UNITED STATES PATENT AND TRADEMARK OFFICE

APPLICATION NO.	FILING DATE	FIRST NAMED INVENTOR	ATTORNEY DOCKET NO.	CONFIRMATION NO.
10/070,501	03/07/2002	Vladimir Kliatzkin	468/1	7024
24101	7590	12/09/2005	EXAMINER	
BRUCE E. LILLING LILLING & LILLING P.C. P.O. BOX 560 GOLDEN BRIDGE, NY 10526			ALEJANDRO, RAYMOND	
			ART UNIT	PAPER NUMBER
			1745

Office Action Summary

DETAILED ACTION

Figure 6 below illustrates the specific battery embodiment and it can be appreciated that the “cellophane” separator material mostly wraps, covers or envelops both electrode plates 33 and 34:

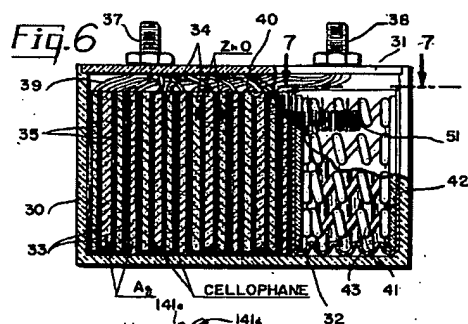
Yardney disclose an electric battery comprising a casing an a substantially vertical partition horizontally movable therein; an electrode assembly in said casing including a plurality of electrode plates and separator means between said plates; pressure exerting means inserted in said casing on the other side of the partition; thereby maintaining said electrode assembly under compression between said partition and the other of said walls (CLAIM 1). The battery comprises a liquid electrolyte permeating said electrode assembly and a flexible electrolyte-impermeable envelope surrounding said pressure-exerting means (CLAIM 2). Yardney discloses the factor of maintaining constant internal pressure (COL 3, lines 5-45). *Thus, Yardney is concerned with counteracting periodic changes of electrode volumes.*

Yardney also discloses the use of positive and negative electrodes consisting essentially of zinc oxide and silver, respectively (COL 3, lines 53-64) which are spaced from one another by separators made of cellophane (COL 3, lines 57-65).

Enlarged portion of Figure 6 illustrate that the separator material, at a minimum, wraps, covers or envelops three (3) sides of the electrode plates:
